METROPOLITAN GOVERNMENT OF NASHVILLE AND DAVIDSON COUNTY

STAFF RECOMMENDATION
915 Fatherland Street
April 17, 2013

Application: New construction
District: Edgefield Historic Preservation Zoning Overlay
Council District: 06
Map and Parcel Number: 08216018100
Applicant: Van Pond, Jr./ Van Pond Architect, PLLC
Project Lead: Robin Zeigler, robin.zeigler@nashville.gov

This image shows how the home is setback enough from the historic building to the right that the addition of a front porch will still maintain the established historic front setbacks.

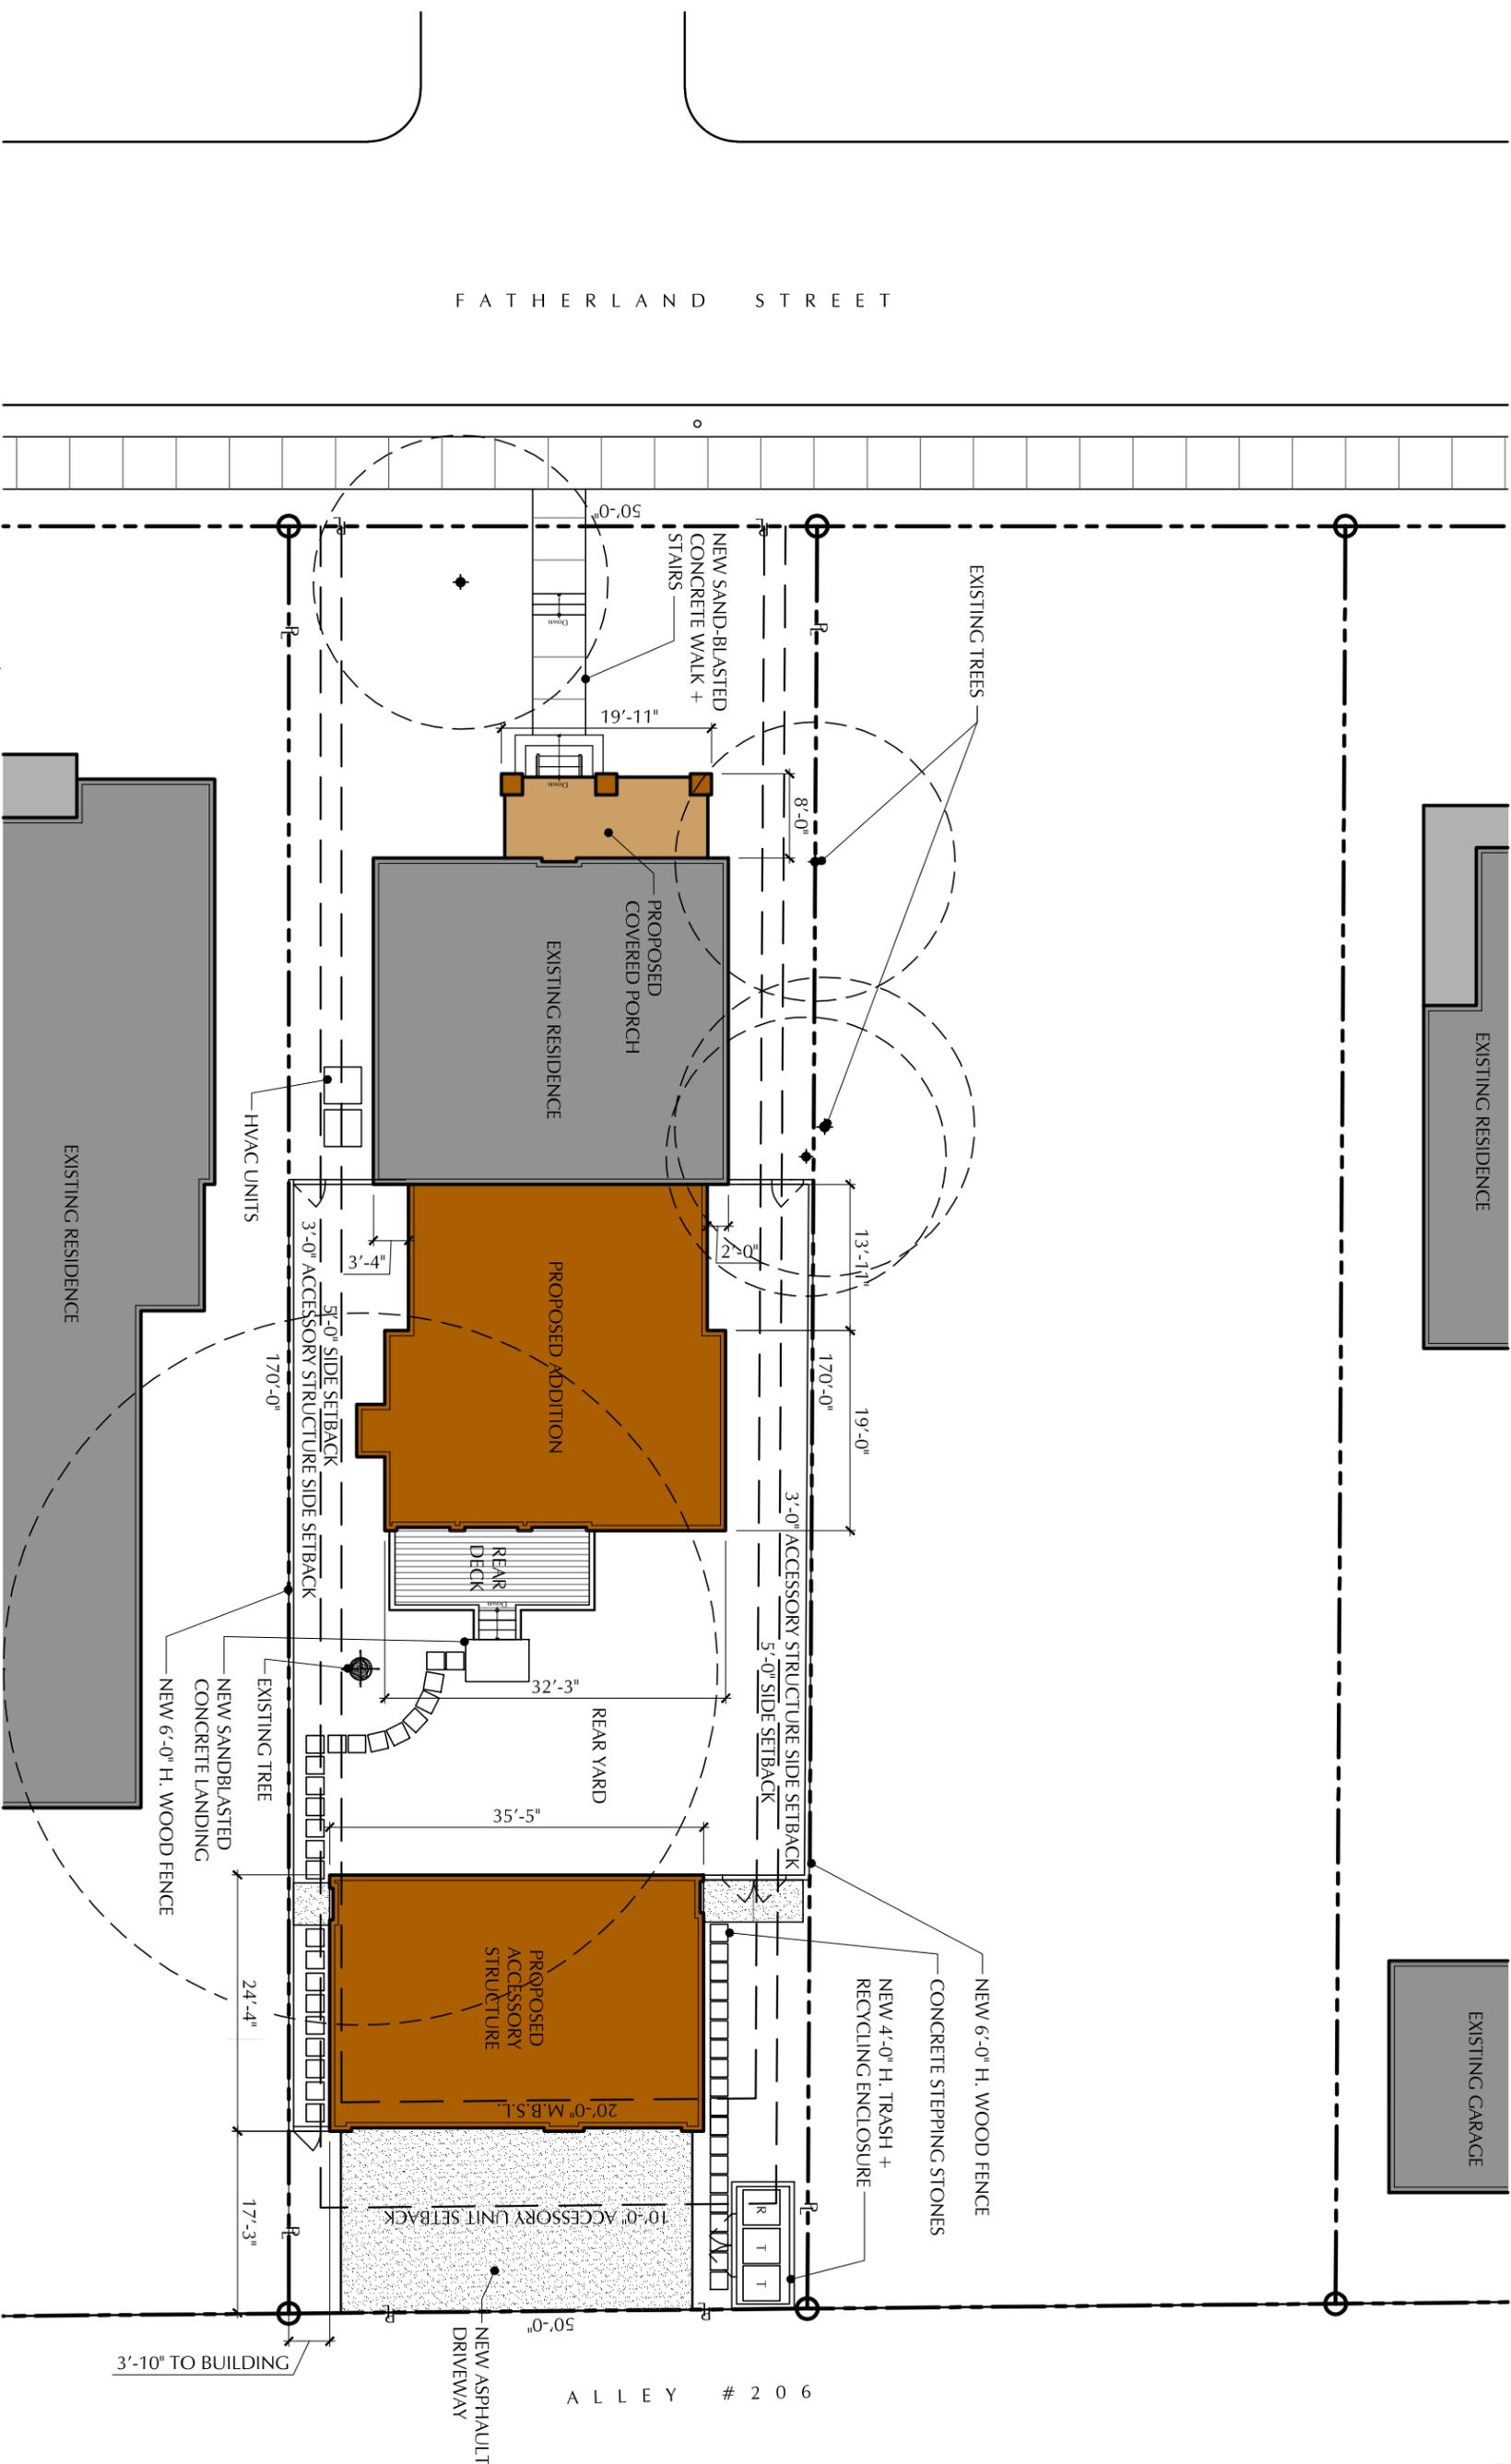
Setback and Rhythm of Spacing: The setbacks meet all bulk zoning requirements and only the front and rear setbacks will change. The front setback will change due to the addition of the front porch and will now be in line with the historic home to the right. The project meets section II.B.2.a.

Proposed Fatherland Street Elevation (South)
SCALE 1/8" = 1'-0"

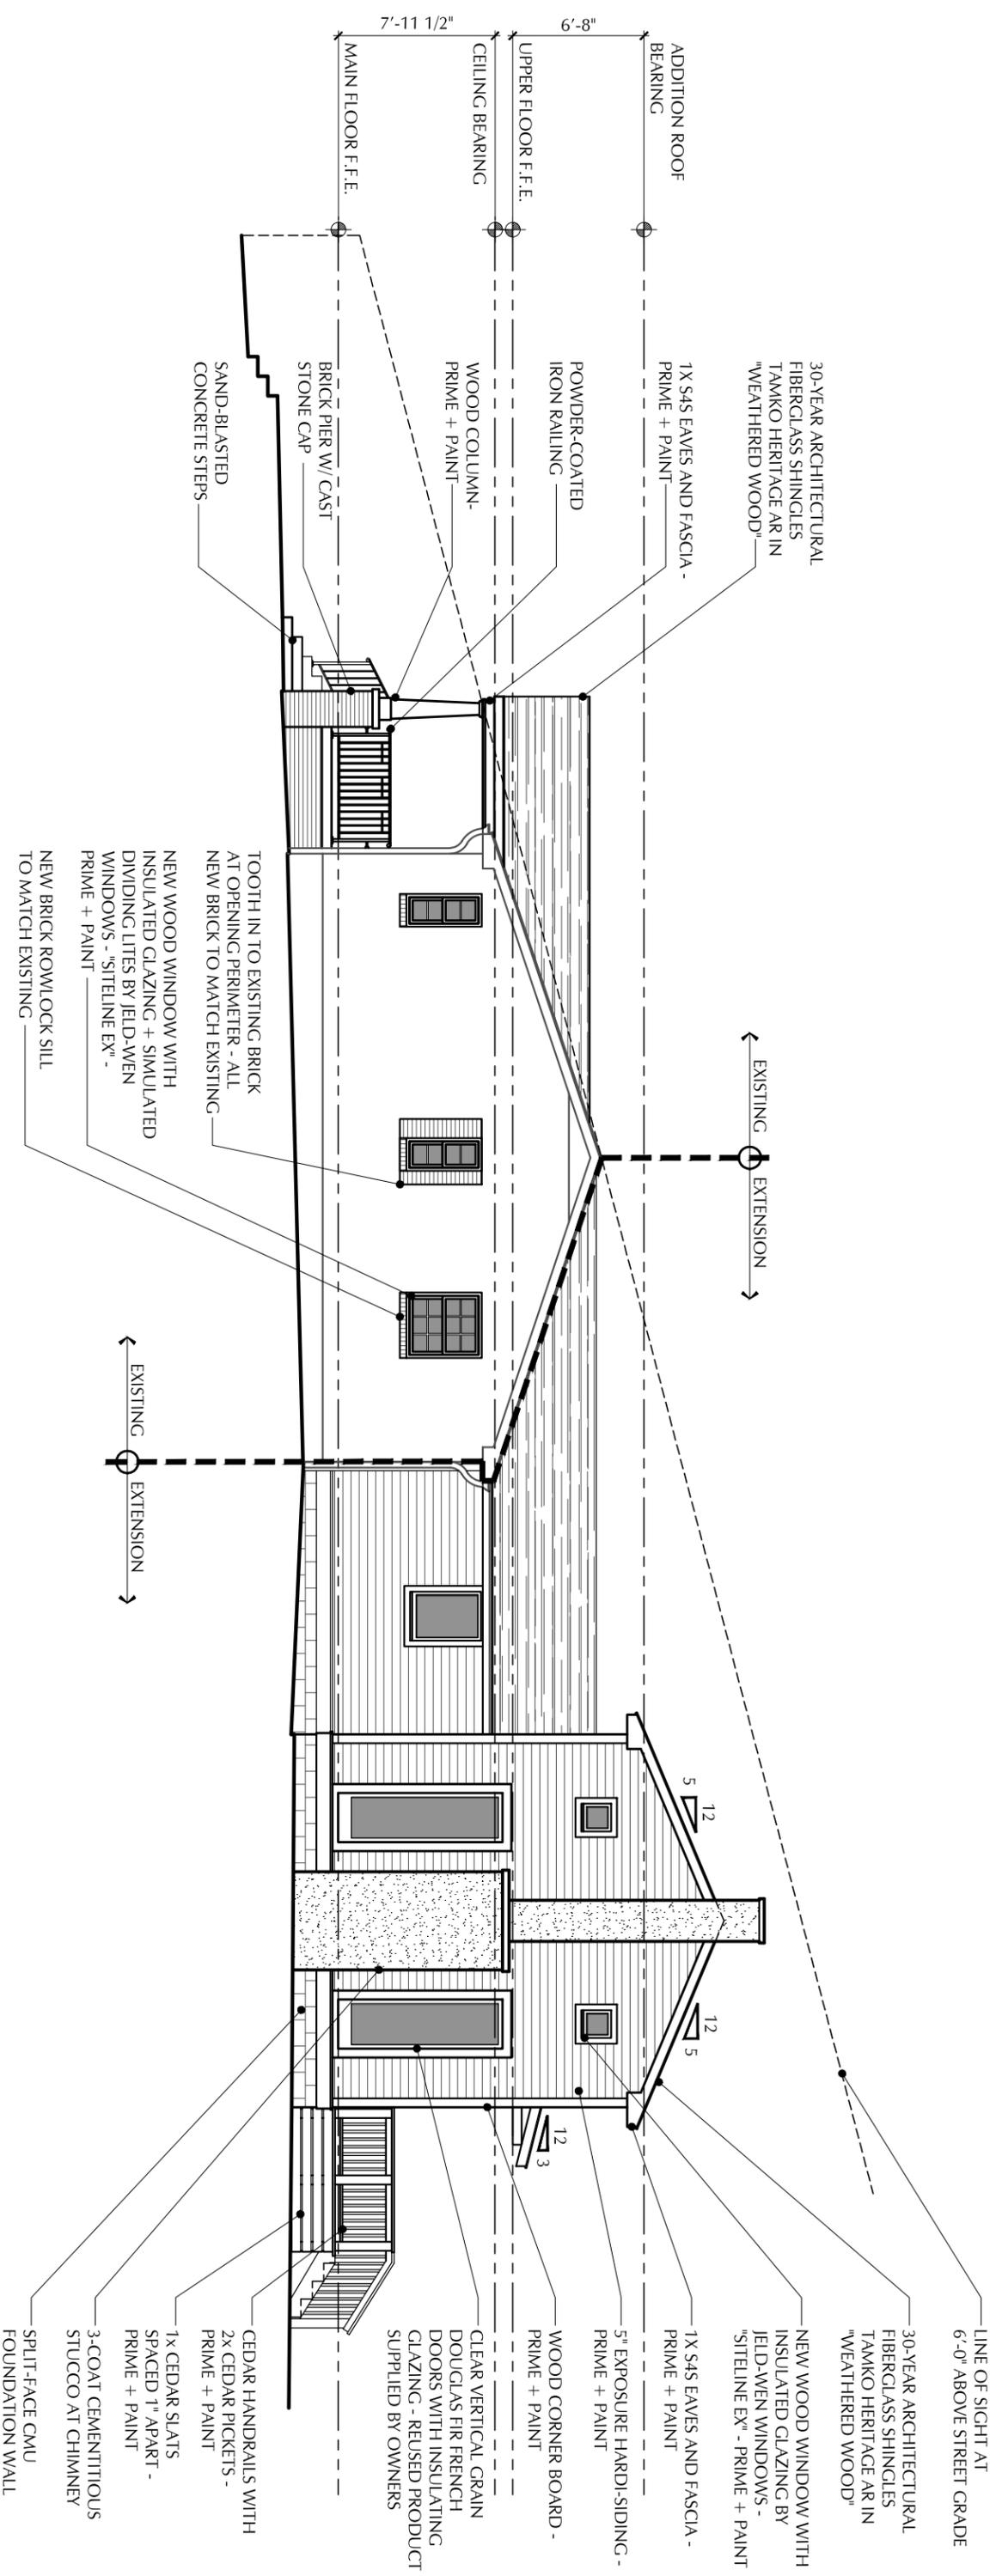
Height: The height of the first half of the building is existing and will not change. The proposed addition will be twenty-four feet (24') from the lowest grade on the front, which is in keeping with the range of heights in the immediate vicinity which are between eighteen and thirty four feet (18'-34') tall. The addition will be approximately six feet (6') taller than the existing building, which could be inappropriate for a historic home but is appropriate for this building which is shorter than the majority of historic buildings in the area. The additional height is also mitigated by the fact that it does not take place until forty-five feet (45') beyond the front wall of the house and the majority of exposed material on the front elevation is roof rather than siding. The foundation height of the addition will match the height of the existing foundation. The eave height of the porch will match the eave height of the existing house. The project meets section II.B.2.b.

Orientation: The home's orientation will not change and is consistent with historic buildings in the neighborhood. The house will address Holly Street with a centered primary entrance, the addition of a front porch and a walkway leading to Holly Street. The project meets section II.B.2.e. of the design guidelines.

Materials Texture, Details, and Material Color: The foundation is split-face CMU block, the roofing is Tamko heritage asphalt shingle in a weathered wood color, the trim is wood, the chimney is stucco and the walkway is concrete. The front porch will have brick piers and wood columns, concrete floor and steps, powder coated iron handrails, roofing to match the house and cedar shingles in the gable field. The rear porch will be cedar.

Proposed Detached Garage Elevation (South)

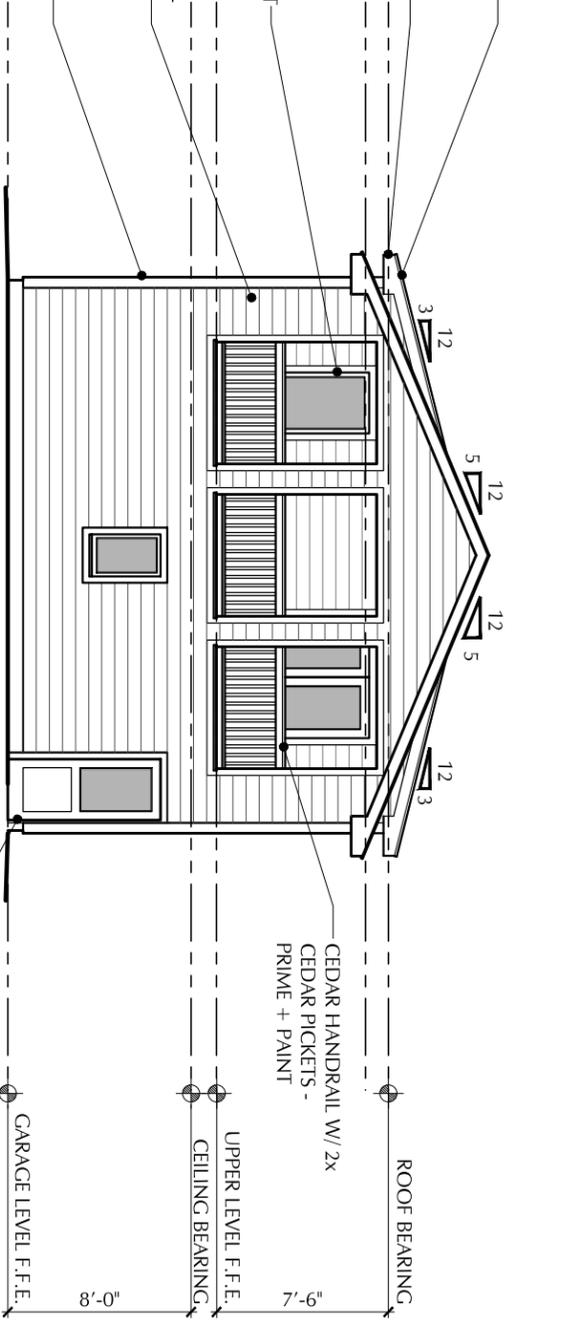
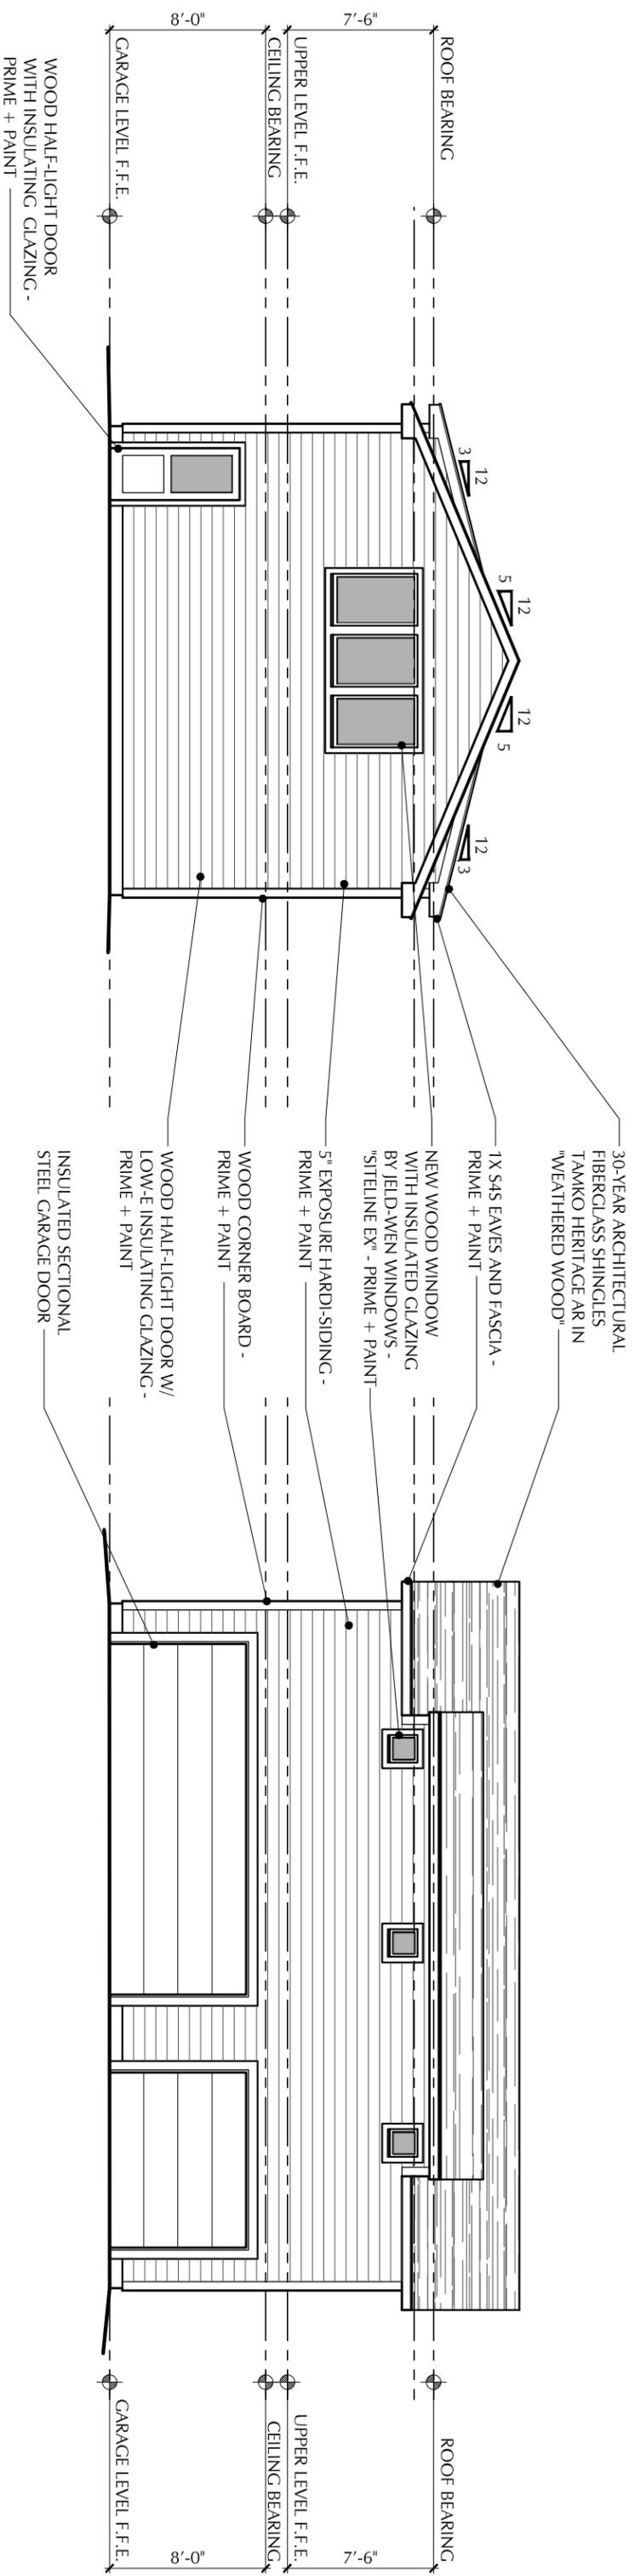
Materials & Design: The character, materials, and roof pitch match the proposed addition, which is more appropriate than matching the existing house since it is non-contributing.

Massing & Scale: Outbuildings are typically subordinate in scale to the primary dwelling; however, in this case the existing building is out of scale for the district. Staff compared the outbuilding to the proposed addition, which is more in keeping with the scale of the district in terms of height but still has a smaller massing than the majority of homes. The garage will have eave and ridge heights that are approximately one foot

shorter (1') than the addition. The width of the garage is thirty-five and one-half feet (35' 6") compared to the addition which is thirty-two feet (32') wide. Although the garage is barely subordinate to the addition, it is in keeping with other outbuildings in the area.
